Service Bulletin No. 383B

MODEL E4500 / J4500 Series Coaches	TYPE Field Change Program	SECTION/GROUP 11 – Steering	DATE June 13, 2012
SUBJECT POWER STEERING VIBRATION			
CONDITIONS

THIS BULLETIN SUPERSEDES SERVICE BULLETIN 383 IN ITS ENTIRETY.

Figure 1. Existing configuration, pre-retrofit.

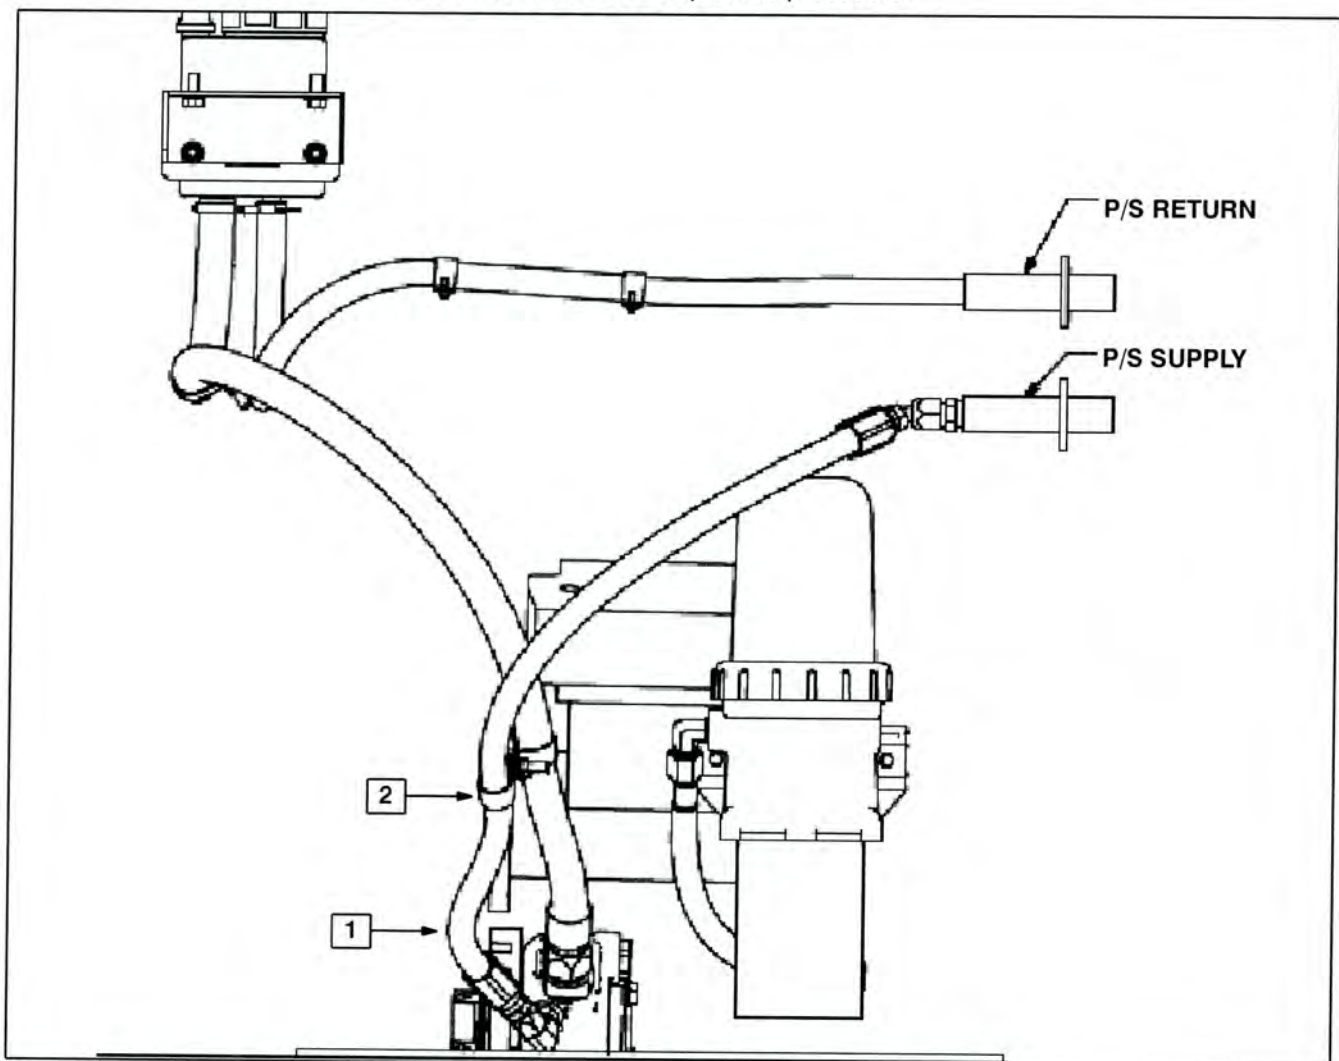
3. Locate the power steering pressure hose (supply), p/n 11-08-1363 (refer to Figure 1). Disconnect the lower end of the power steering pressure hose to drain the oil into a suitable sized container. Discard the oil. Using a clean cloth, wipe clean the installation area.
4. Remove and discard the power steering pressure hose, p/n 11-08-1363, and the clamp (refer to Figure 1). Retain the capscrew and nut to be used at a later step in this procedure.

ITEM	DESCRIPTION
1	Disconnect the lower end of 11-08-1363 hose to drain the system.
2	Discard the 11-08-1363 hose and clamp. Retain capscrew and nut.

Figure 2. Reference photo of suppressor orientation.

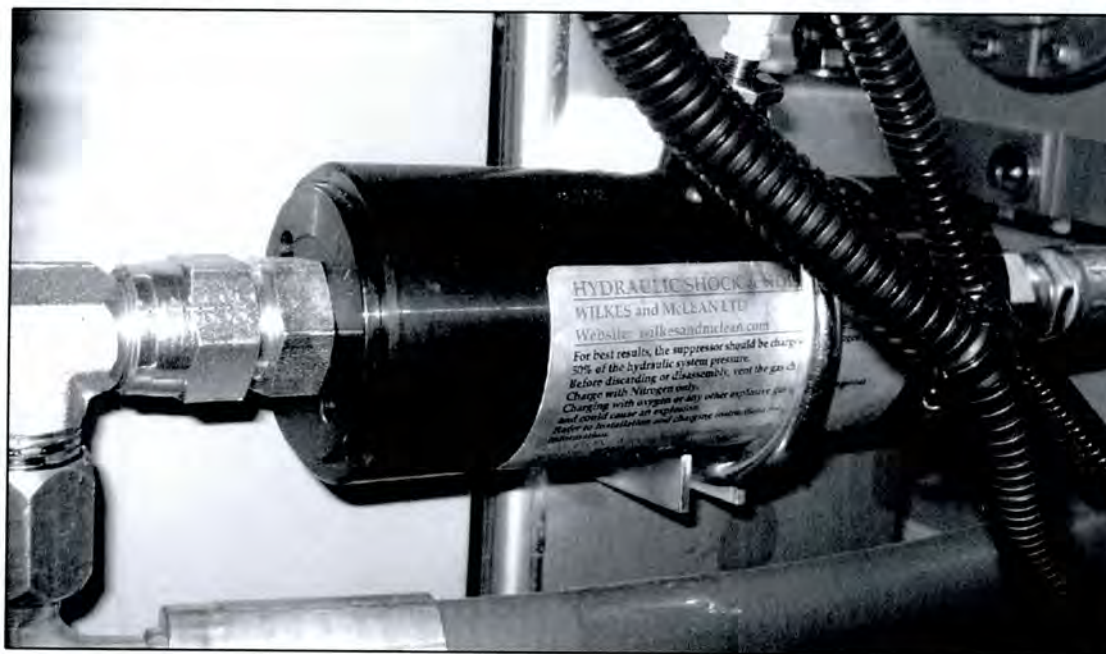
6. On a workbench, assemble the suppressor, p/n 11-08-1450, suppressor o-ring fittings, and fittings, p/n 19-10-872 and 19-10-2481 (refer to Figures 2 and 3 for proper orientation). Using two (2) wrenches (use one { 1 } as a backing wrench), torque suppressor o-ring fittings to 43–48 ft-lbs.

Figure 3.

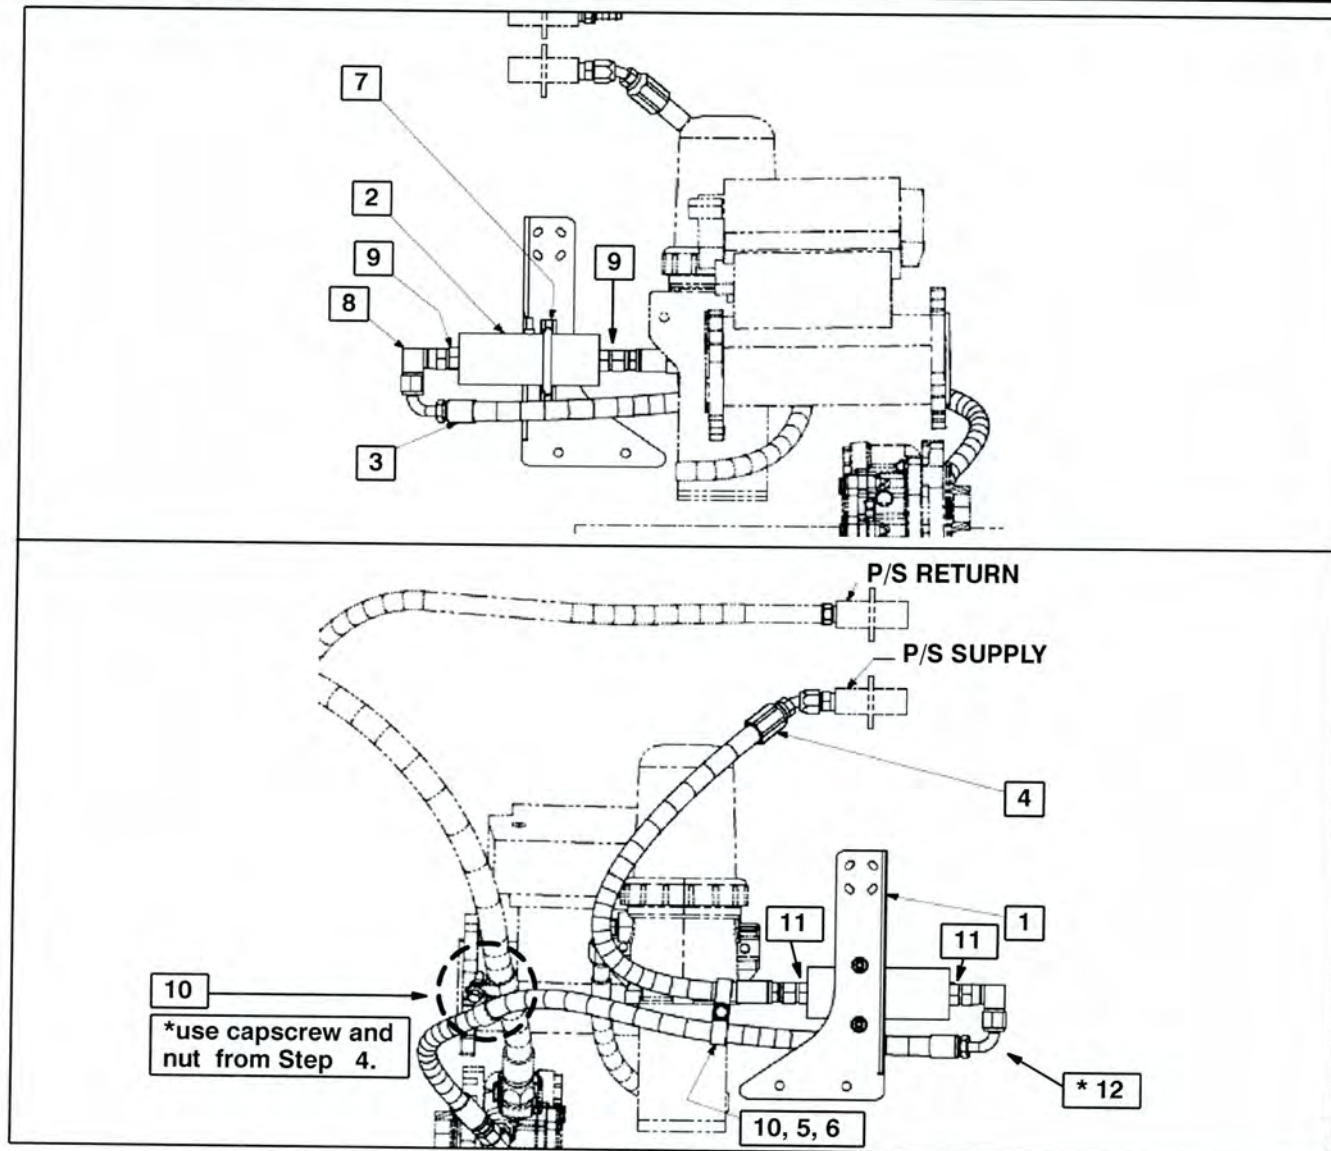
Coaches equipped with a wheelchair lift should install hose assembly, p/n 11-08-1455, on the workbench to avoid having to deploy the wheelchair lift for installation access (see Figure 3).

7. Using the mounting hardware removed in Step 5, install the new bracket, p/n 03-15-5255 (Figure 3).
8. Using the u-clamp, p/n 19-04-0428, mount the suppressor to the Amerex bracket (refer to Fig 3 to 6).
9. Wipe off any residue and orient the power steering pressure hoses, p/n 11-08-1455 and 11-08-1456, as shown in Figures 3 and 4. Using two (2) wrenches (use one { 1 } as a backing wrench on the fitting), torque the four (4) hose ends to 53–63 ft-lbs.
10. Apply torque seal from the face of the hose end to the face of the fitting.
11. Orient the clamps, p/n 19-4-47, on the hoses as shown in Figures 3, 4 and 5. Using the capscrew, p/n 19-01-1516 and nut, p/n 19-03-0495, secure the clamps together.
12. Remove the cap from the power steering reservoir. Add oil, TES-389, to fill up to the MAX line.
